## Noisy compressor MH1050Y

Concerning all appliances with compressor MH1050Y and starting device / motor protection with part number 242 564 073/3.

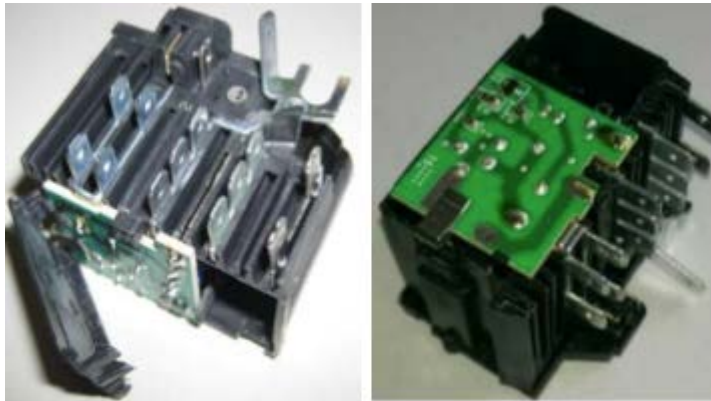
Compressor is sporadically noisy during operation, it sounds as if the compressor is defective.

The starting device switches the auxiliary winding time-controlled to the start of the compressor and not via a PTC. In the event of a fault, the auxiliary winding is switched on sporadically during operation - causing a high noise

Replace the starting device / motor protection number 242 564 073/3.

Old spare part code	New spare part code	Description	From
2425640733	140013370691	Terminal block, Motor protection, SX.J7	From start of production to week 03/19
